EVT 11-89

MIL-STD-1660 TESTS

GENERAL DEFENSE CORPORATION

(VECP 0520E0014R-C)

MODIFICATIONS MADE TO SHEET 5:

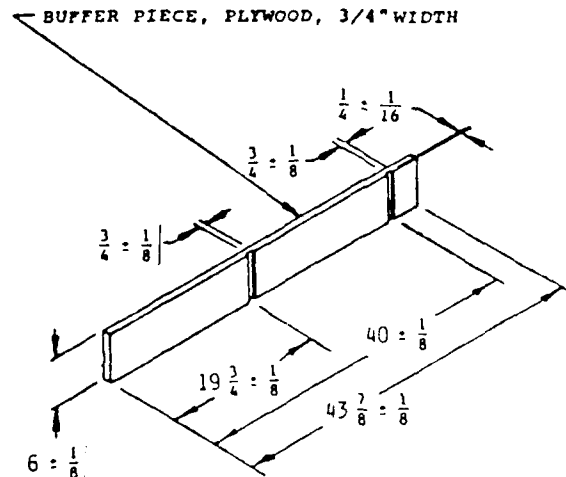
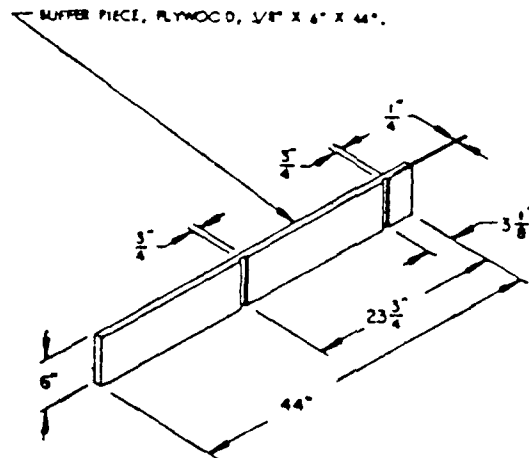
1. CONCLUSIONS. This VECP-designed pallet failed requirements of MIL-STD-1660. Design Criteria for Ammunition Unit Loads. This failure was due to excessive damage (denting) of several containers which results in the inability to remove two of the 120mm rounds. The four-inch-wide dents at the base end of the containers were caused by contact with modified deck boards proposed in the VECP.

2. DISAPPROVAL. Due to the damage resulting during MIL-STD-1660 tests, the VECP submitted by GDC is not approved for use. Tests conducted by USADACS demonstrated that the VECP submitted by GDC did not adequately protect the rounds.

MODIFICATIONS MADE TO SHEET 5 (SHEET 2 OF 2):

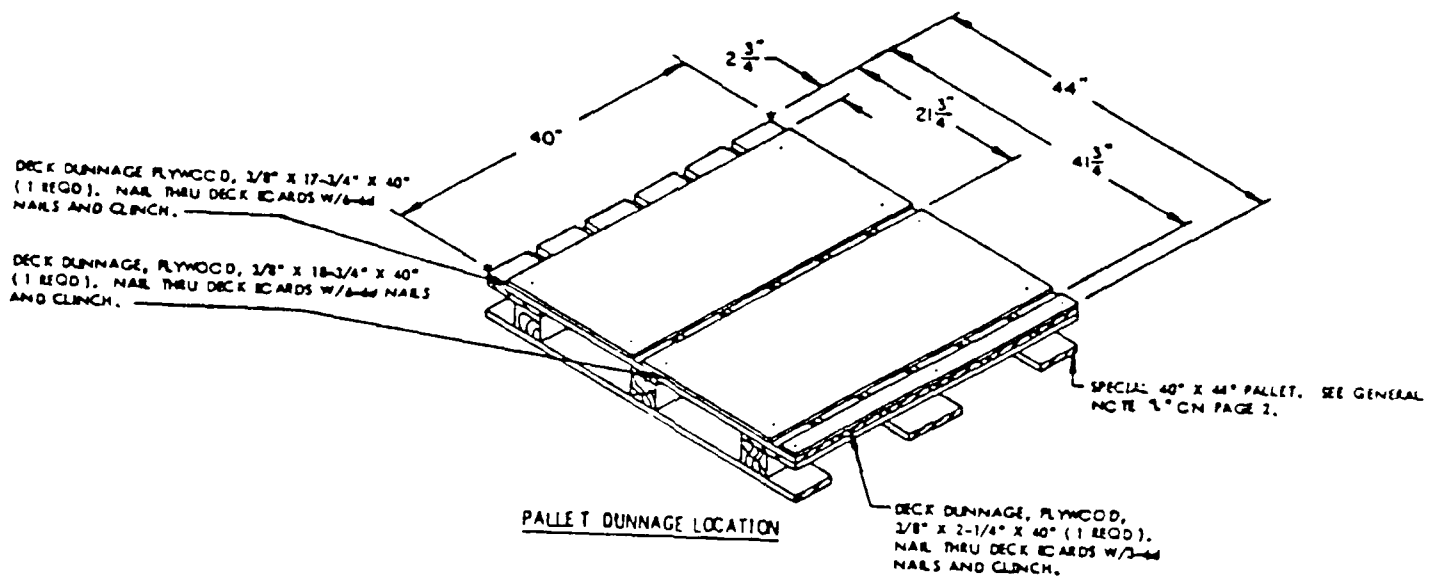
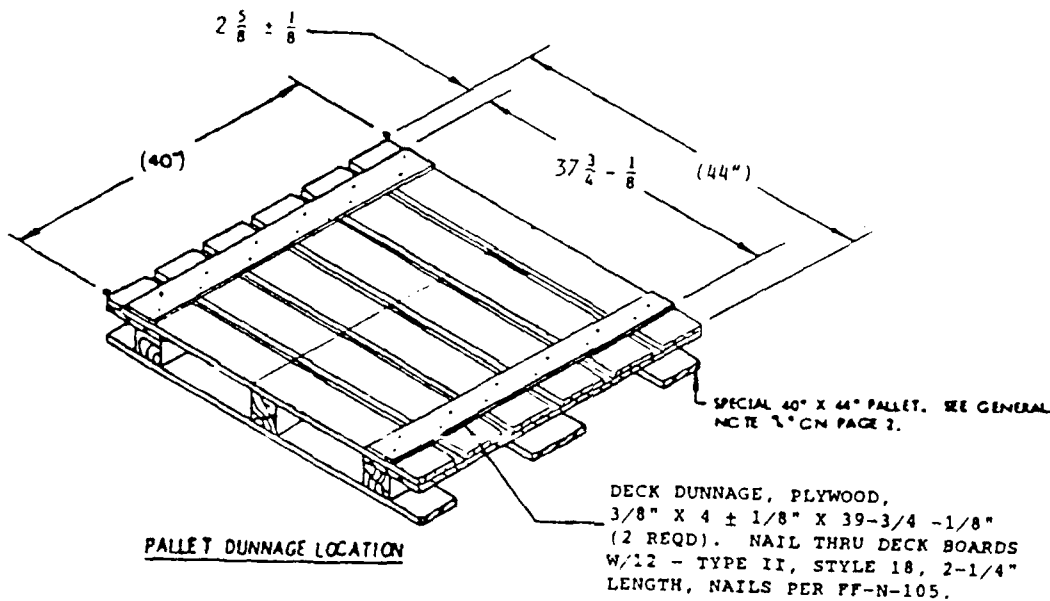
The present TDP identifies pallet dimensions without tolerances. With producibility in mind, GDC evaluated the pallet design and developed tolerances for the identified dimensions. After full-scale layouts (max/min conditions) of the pallet and container were completed, several functional characteristics of the pallet were found to be of no value due to manufacturing tolerances. Accordingly, a design evaluation was conducted to resolve this problem.

- o Two pallet dunnage components rather than three.
- o 12 nails per dunnage component rather than 6.
- o Less dunnage area.
- o Tighter functional tolerances.

Selection of two pallet dunnage components rather than three is based upon the tolerance range about the container middle ring. Due to the dimensioning practice in the present design of the wood pallet, it is not possible to maintain a tolerance around the middle ring which provides satisfactory functional characteristics. Accordingly, this section of the pallet dunnage was eliminated. In addition, the small strip of dunnage at the container base was eliminated since it is not required to constrain movement.

Vendor feedback has identified problems with the current design surviving shipment between the wood pallet manufacturer and the LAP facility. GDC has reviewed this problem and recommends that six (6) additional nails be used per dunnage component.
